Date : January 19, 1962

Subject : Current Configurations of Pressure Suit and Parachute

FULL PRESSURE SUIT 1962
OXCART

SAME RIG AS

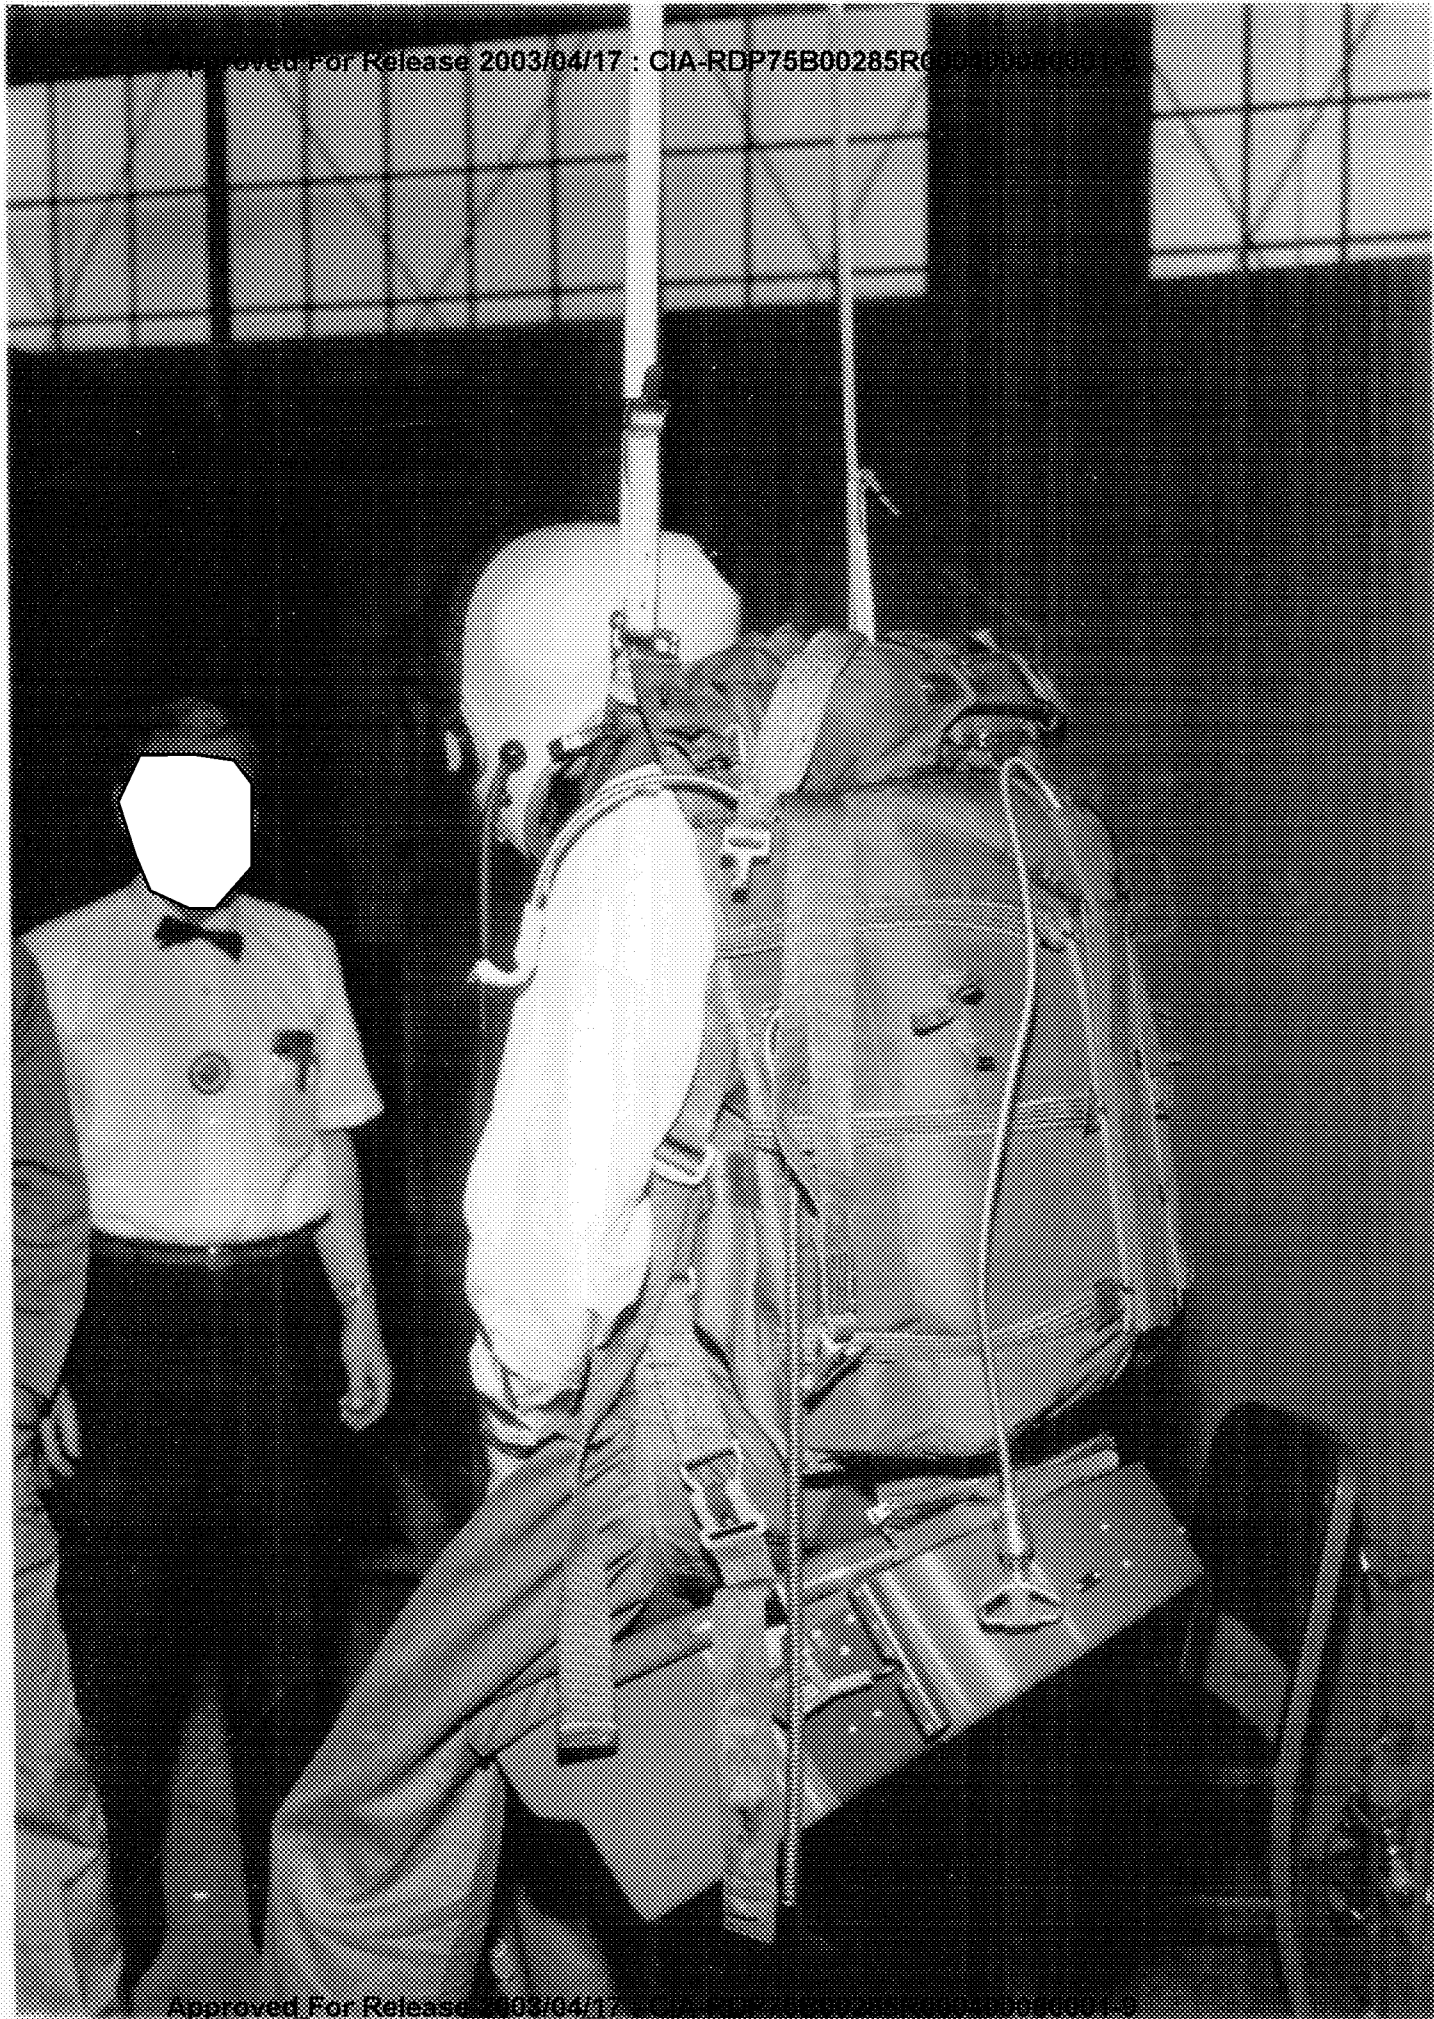
- a) CLEARS HELMET OK
- b) COMPLAINS ABOUT COMFORT
AT LEGS AND NECK
- c) PRESSURE FROM NECK COLLAR

a) SUIT AND NECK-SPREADER COLLAR

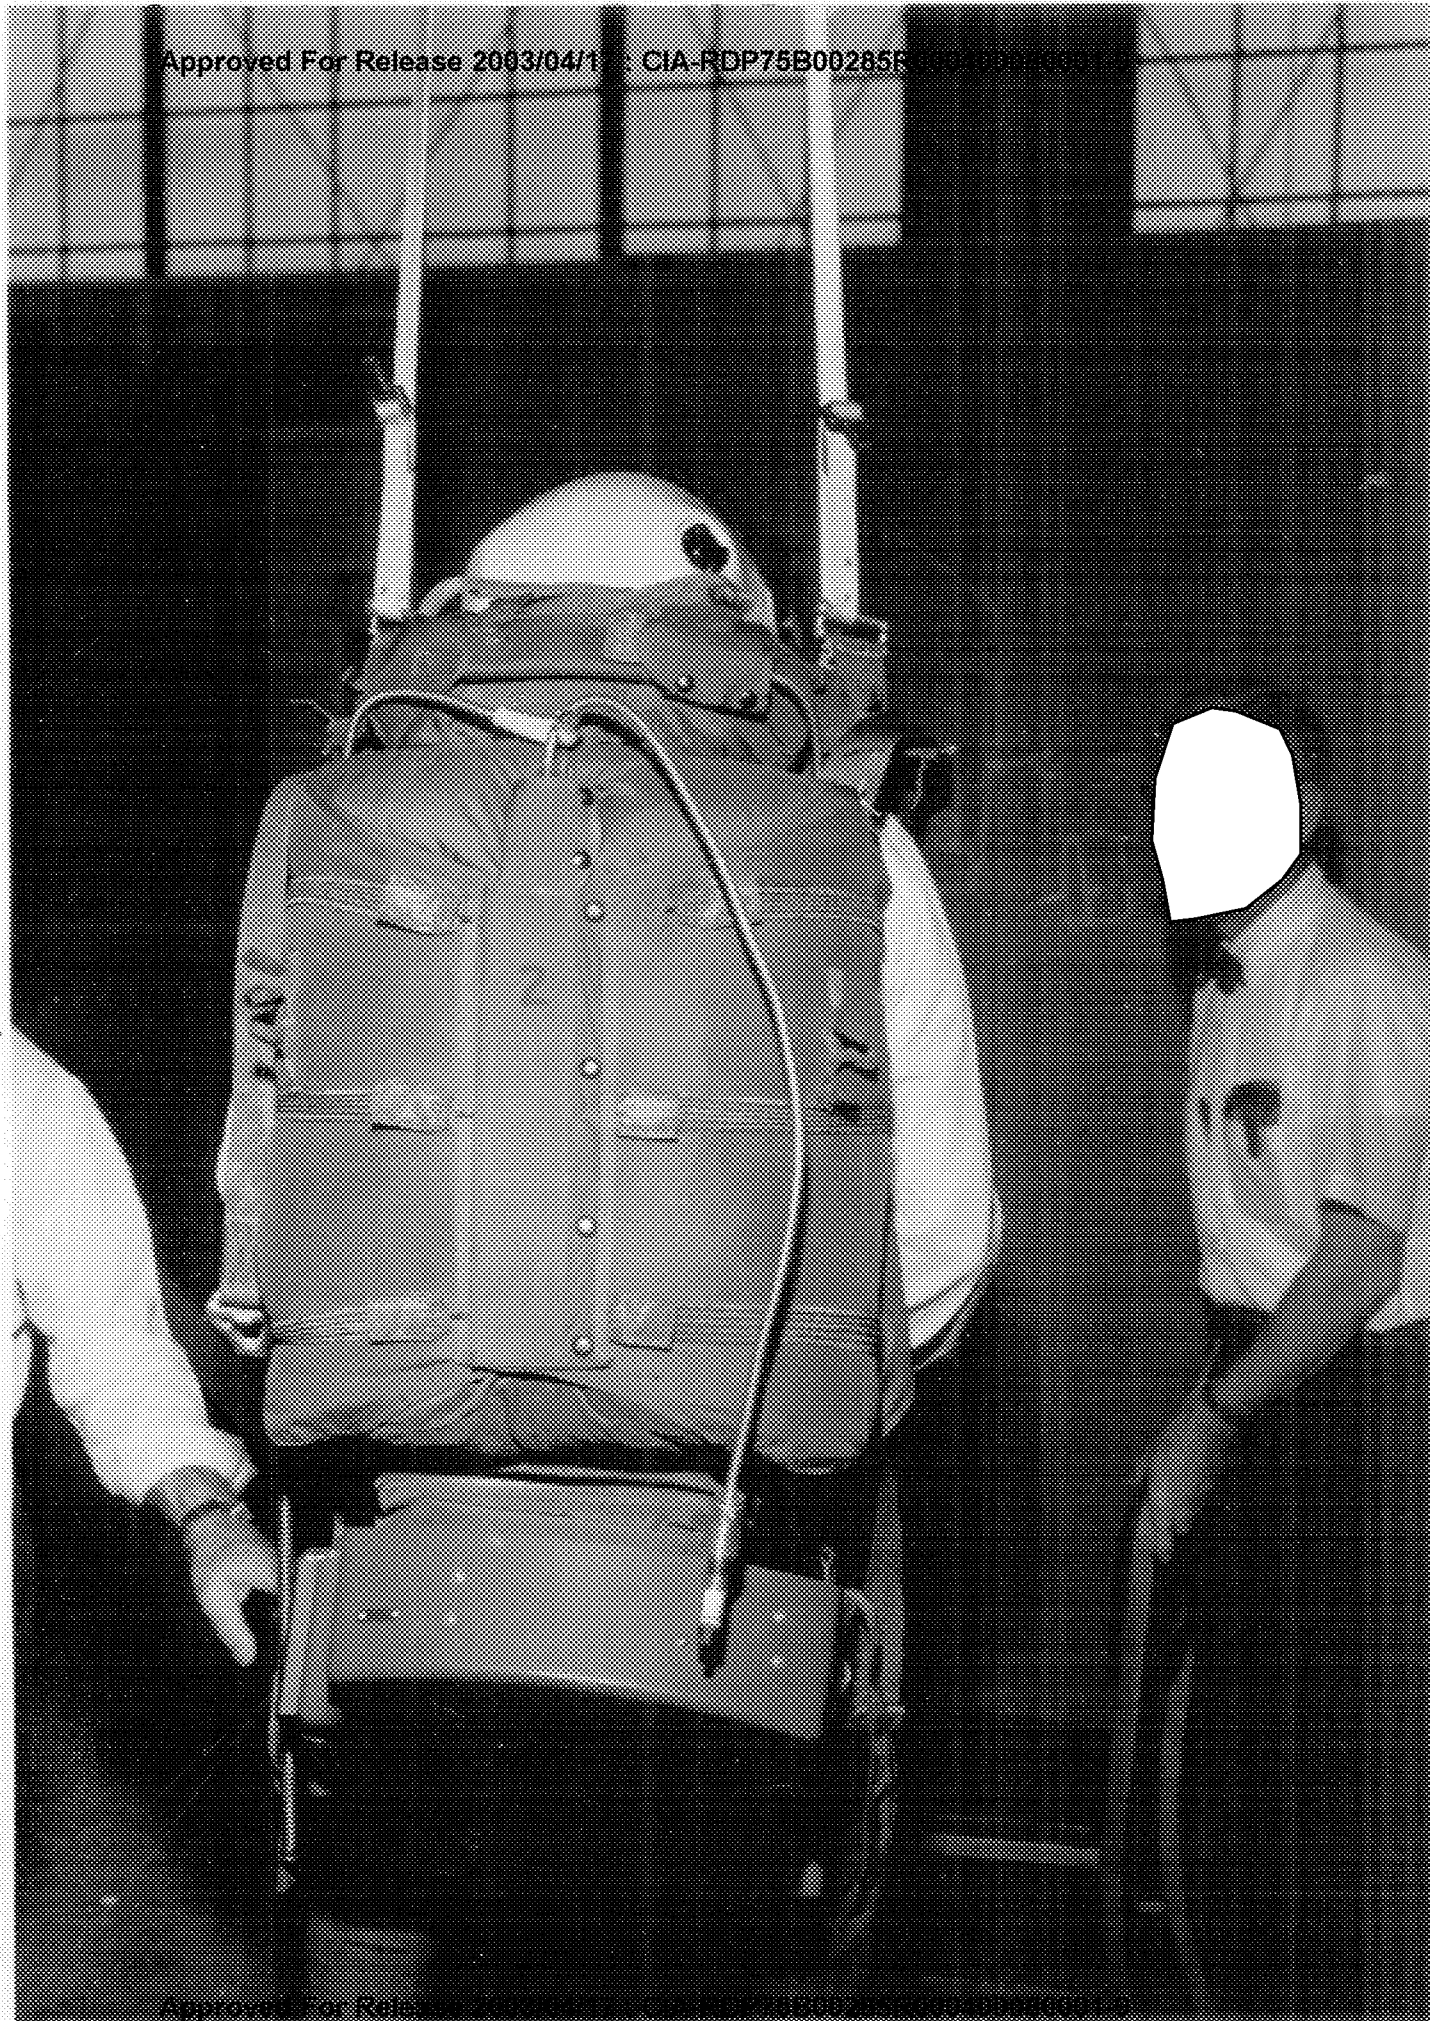
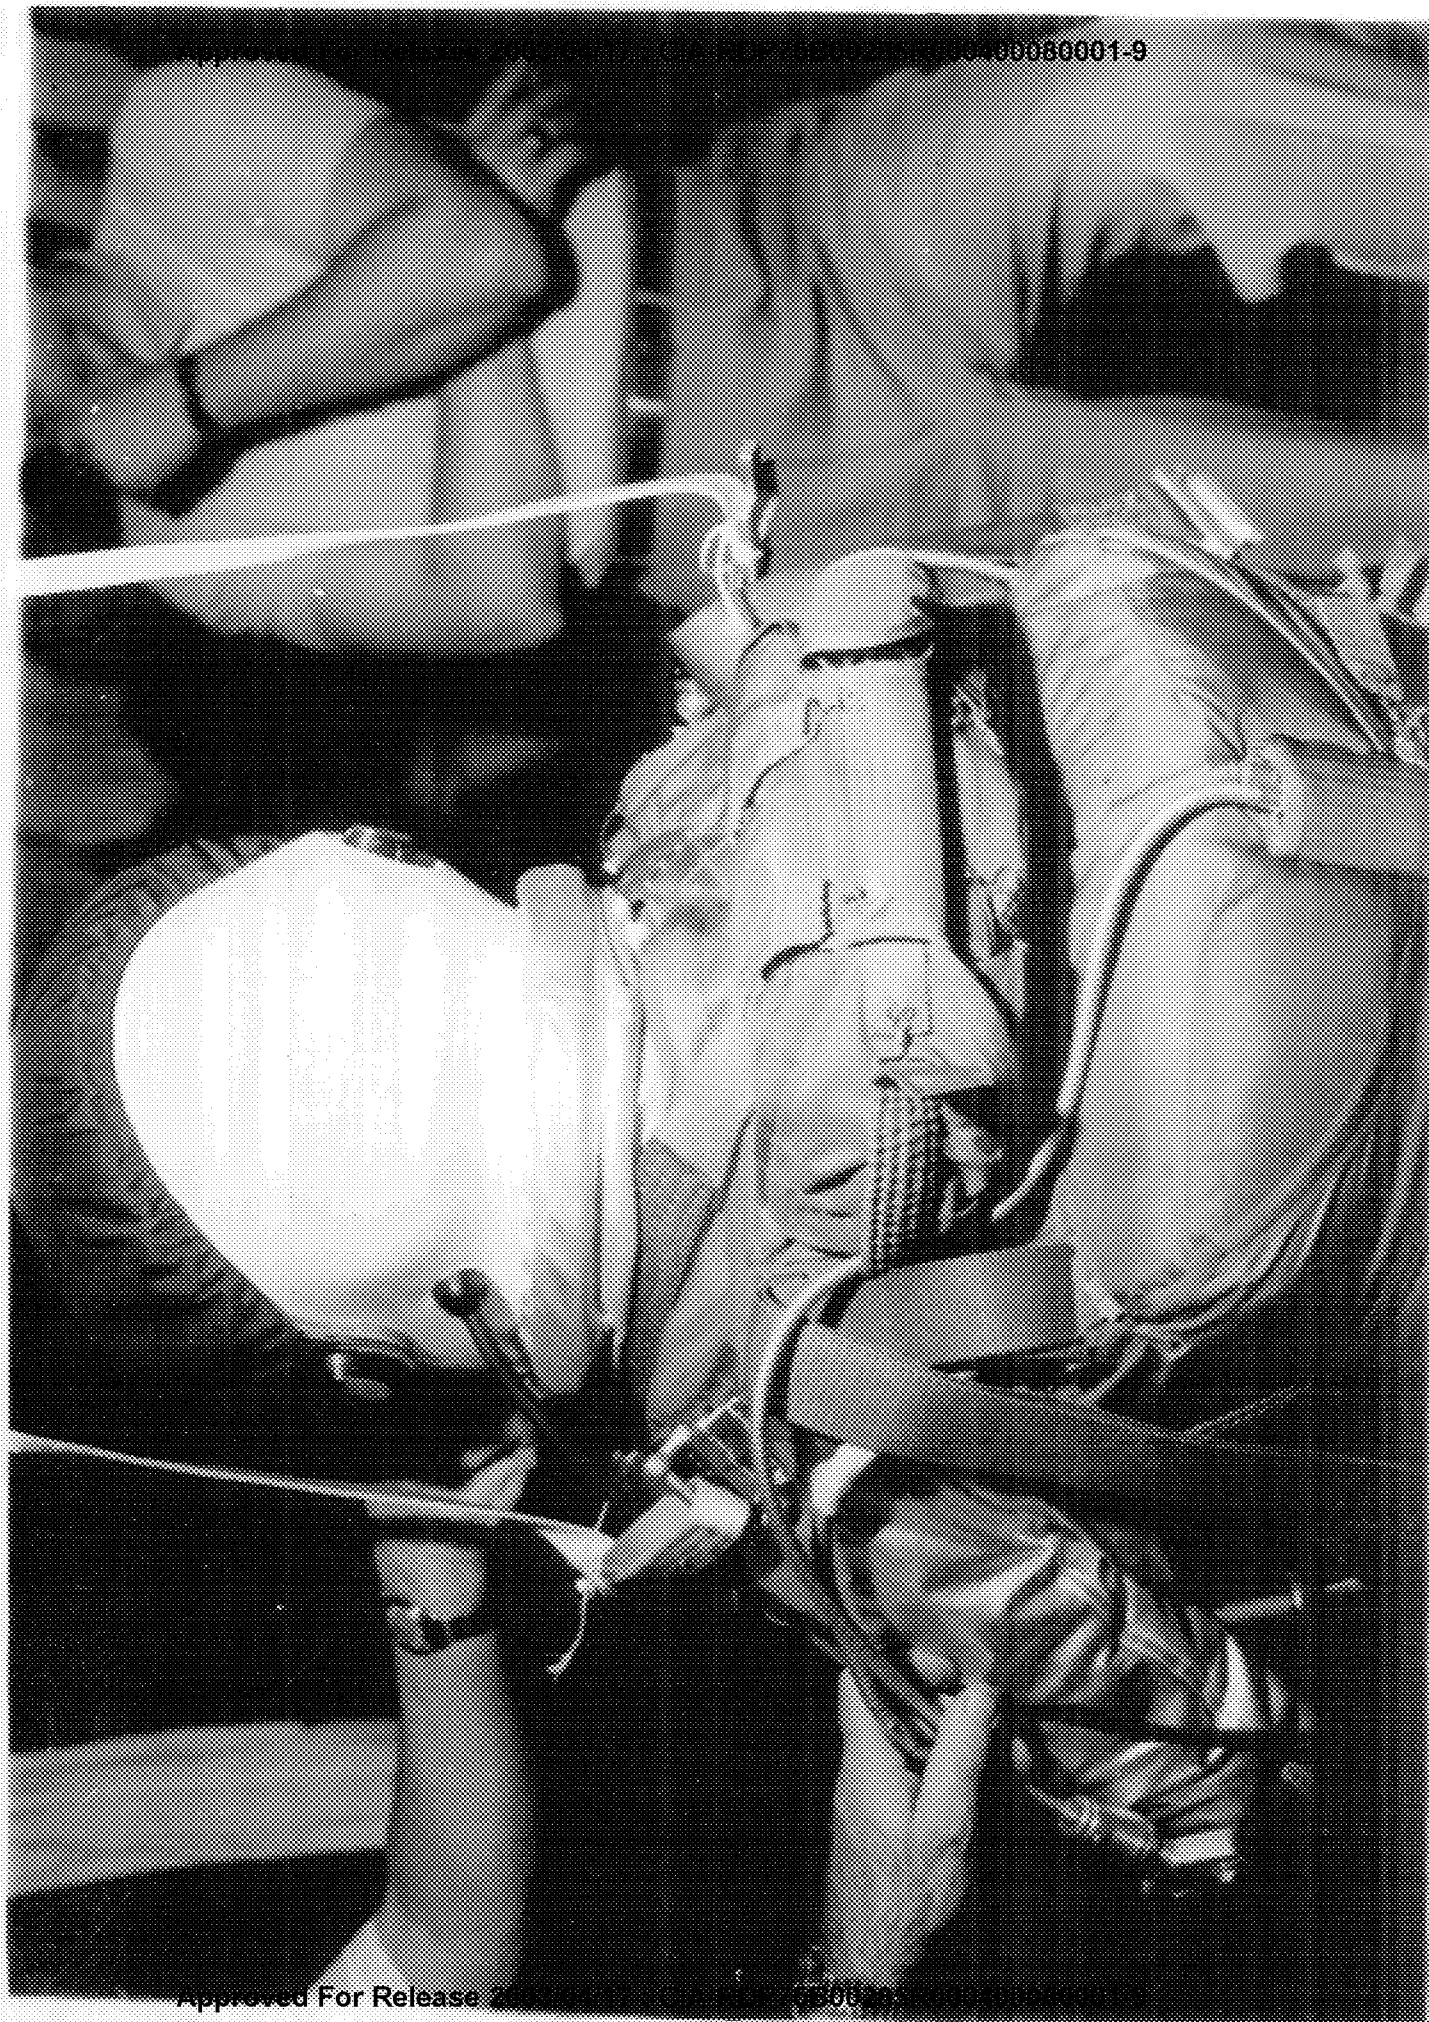
a) CONSIDERS SUSPENSION ACCEPTABLE

b) LEG AND GROIN OK

c) NO NECK PRESSURES

d) CHEST PRESSURES APPEAR OBVIOUS
FROM MANNER OF SUSPENSION

- a) SAME AS #4 WITH 5" OPEN
POINT 1" FWD
- b) ~~HIS~~ NECK COLLAR PLACED OUTSIDE

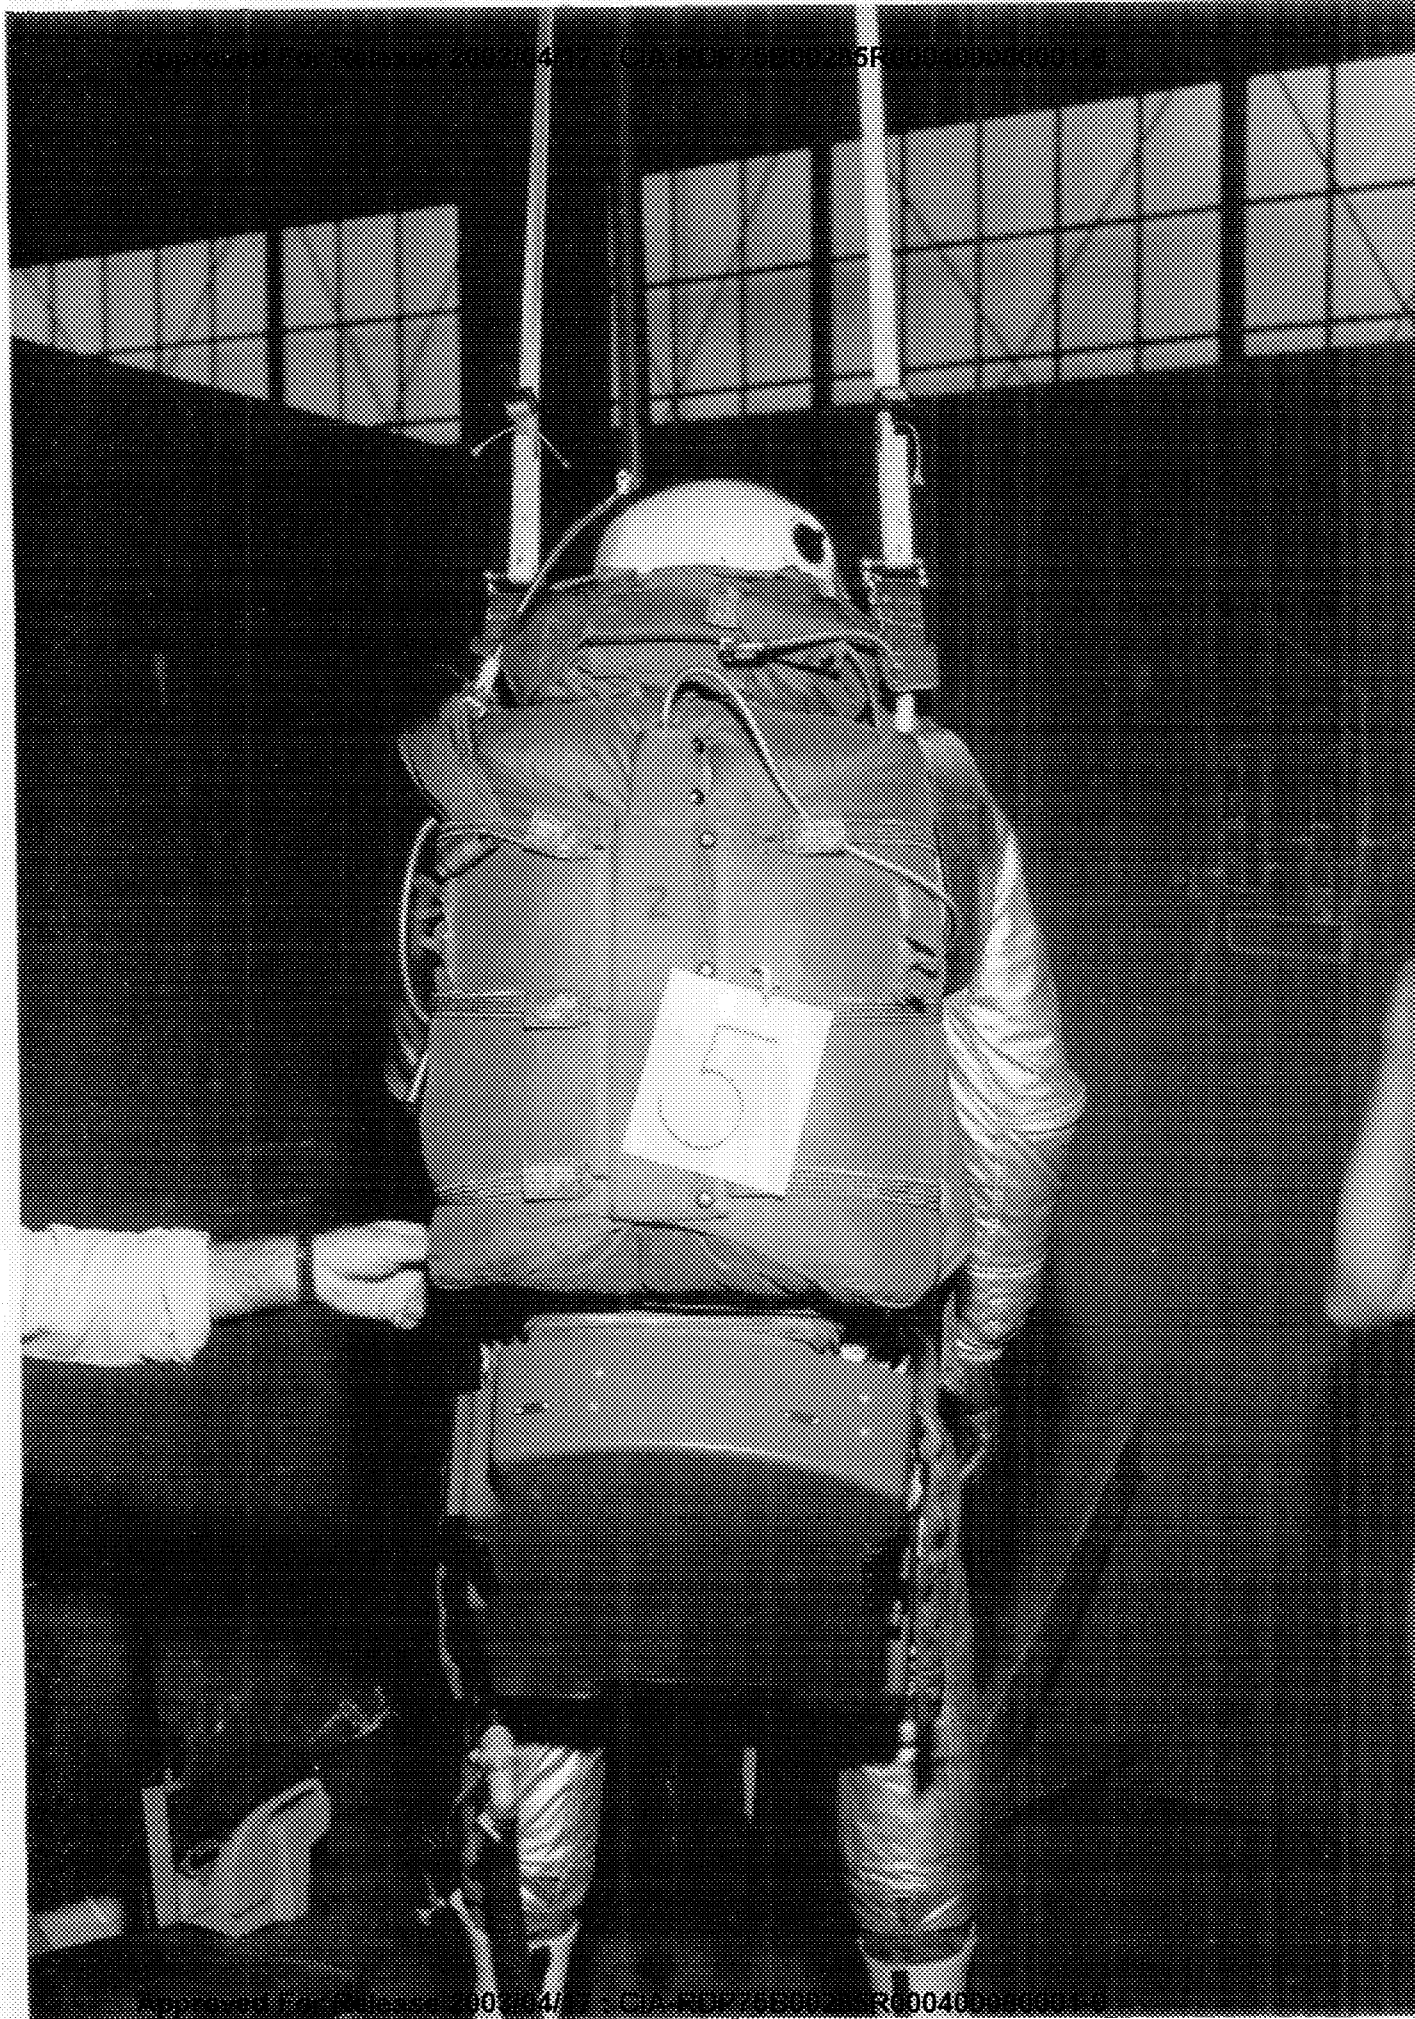
- a) FEELS MORE COMFORTABLE THAN #4
- b) CHEST PRESSURES LIGHTER THAN #4
- c) NO NECK PRESSURES
